HERITAGE PRESERVATION APPLICATION SUMMARY

Property Location: 419 Washington Avenue North
Project Name: Office Building
Prepared By: Lisa Steiner, Senior City Planner, (612) 673-3950
Applicant: DJR Architecture
Project Contact: Aron Johnson
Ward: 3
Neighborhood: North Loop
Request: To construct a ten-story office building with a connection to an existing building.
Required Applications:

Certificate of Appropriateness	To allow the construction of a new building and the construction of a connection to an existing building.
---------------------------------------	---

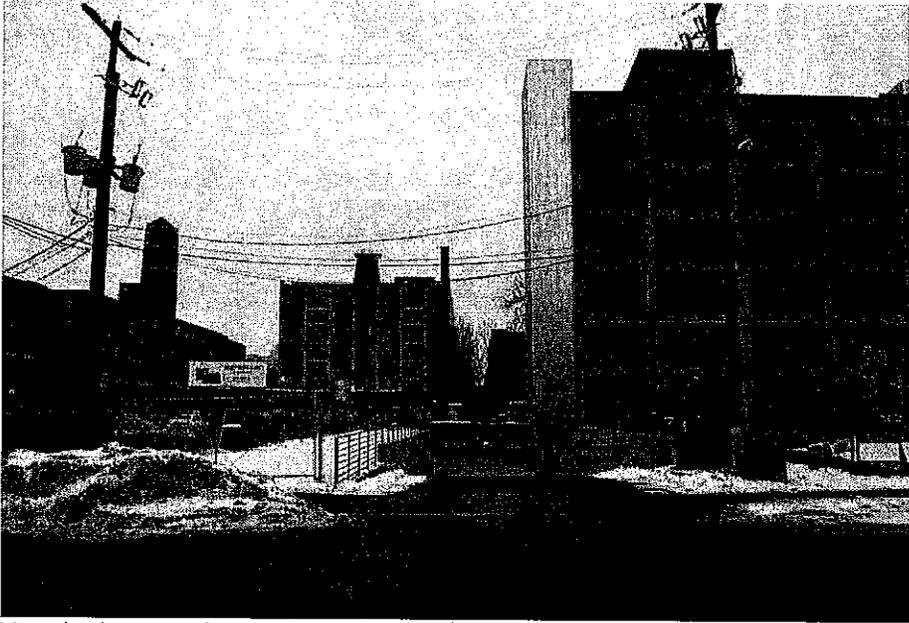
There do seem to be some objects that are visible within the spur rail corridor. I would advise limiting the connection to one level either at the second or third floor to keep it lower in the view shed. Is there also a possibility of providing some sort of "public green space or other amenities" in the spur area? I realize that the "railway spur" will be the only access to the back of the Washington Ave. building. I am not sure if there is access through the parking lot or not? Regardless, maybe some type of paving could mark the memory of the railroad spur; provide a drivable surface and also comply with the Advisory 1.6. I make this suggestion because the DJR site study sketch 10.07.15 shows the "Access drive at the existing alley widened" and I am not sure how much additional width is required. This is something we should discuss.
